PCN Number:	20130909003			PCN Date:	09/13/2013						
Title:	Carrier Tape Packing Material change for LM3530UMX Device										
Customer Contact:	PCN Manager	Phone:	+1(214) 480-6037	Dept:	Quality Services						
Change Type:											
<input type="checkbox"/>	Assembly Site	<input type="checkbox"/>	Assembly Process	<input type="checkbox"/>	Assembly Materials						
<input type="checkbox"/>	Design	<input type="checkbox"/>	Electrical Specification	<input type="checkbox"/>	Mechanical Specification						
<input type="checkbox"/>	Test Site	<input checked="" type="checkbox"/>	Packing/Shipping/Labeling	<input type="checkbox"/>	Test Process						
<input type="checkbox"/>	Wafer Bump Site	<input type="checkbox"/>	Wafer Bump Material	<input type="checkbox"/>	Wafer Bump Process						
<input type="checkbox"/>	Wafer Fab Site	<input type="checkbox"/>	Wafer Fab Materials	<input type="checkbox"/>	Wafer Fab Process						
PCN Details											
Description of Change:											
Carrier Tape Material change for LM3530UMX Device. Pack material differences are shown below:											
<table border="1"> <thead> <tr> <th style="background-color: #92d050;">Pack BOM</th> <th style="background-color: #92d050;"

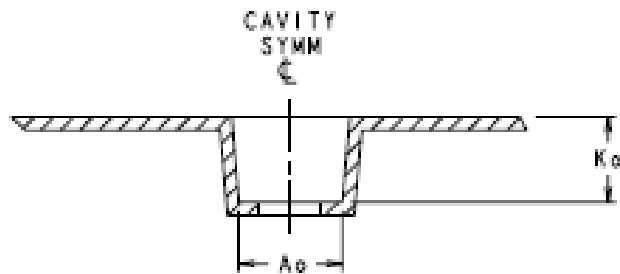
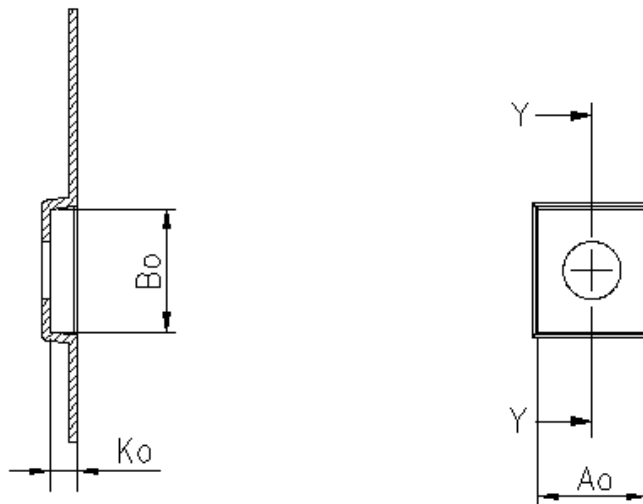
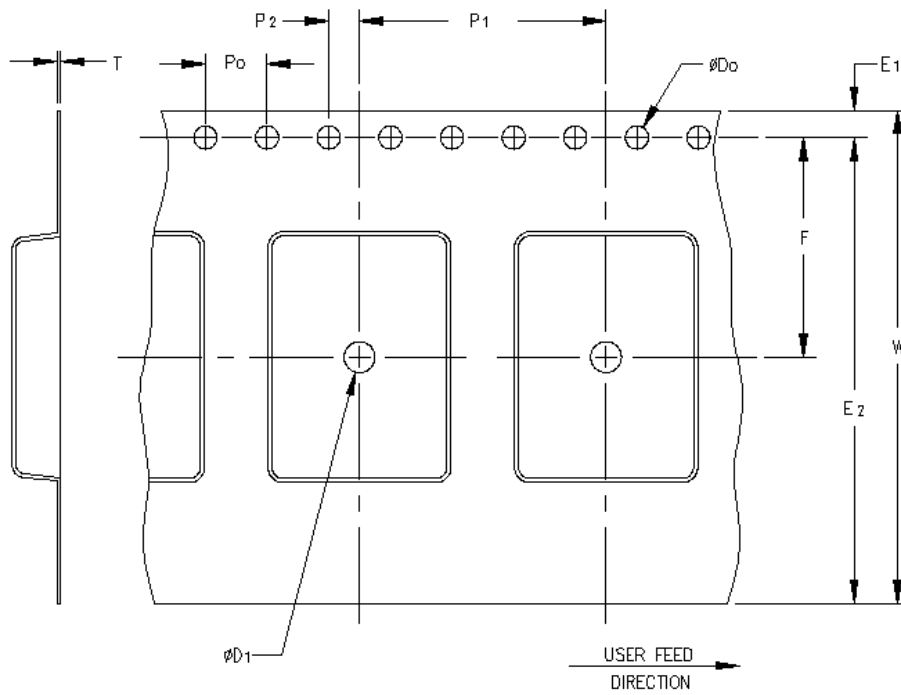
FROM CARRIER TAPE: 8097067-0001

A _o	1.35 +/−0.05
B _o	1.65 +/−0.05
K _o	0.56 +/−0.05
F	3.50 +/−0.1
P ₁	4.00 +/−0.1
W	8.00 +/−0.3

TO CARRIER TAPE: 4212589-0014

A_0	1.37 \pm 0.05
B_0	1.77 \pm 0.05
K_0	0.56 \pm 0.05
F	3.50 \pm 0.1
P_1	4.00 \pm 0.1
W	8.00 \pm 0.3
